AEP-NRC-2015-62
10 CFR 50.90

Donald C. Cook Nuclear Plant Unit 1
Exigent License Amendment Request Regarding Technical Specification 3.3.2,
Engineered Safety Feature Actuation System (ESFAS) Instrumentation

Evaluation of Proposed Exigent License Amendment Request Regarding Technical Specification 3.3.2, Engineered Safety Feature Actuation System Instrumentation

Figure 1

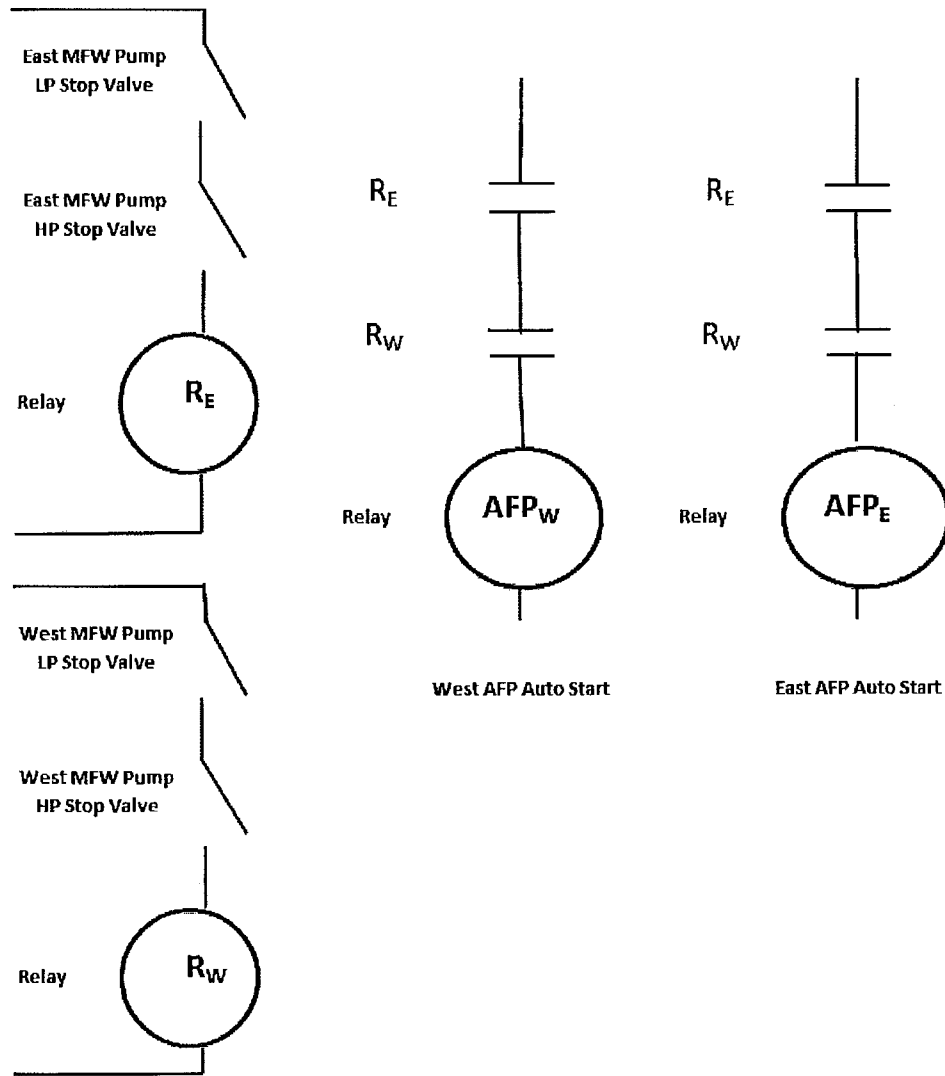
The TS 3.3.2 new Condition H, applies to both anticipatory trip channels. The trip channels are combined using an "AND" logic circuit requiring 4-out-of-4 channels (see Figure 1). Failure of any one of the four (two per MFW pump) channels results in loss of AFW auto-start function. Therefore, the trip channels must be declared OPERABLE within 48 hours of entering Condition H. This Required Action is consistent with the previously applicable Condition B for
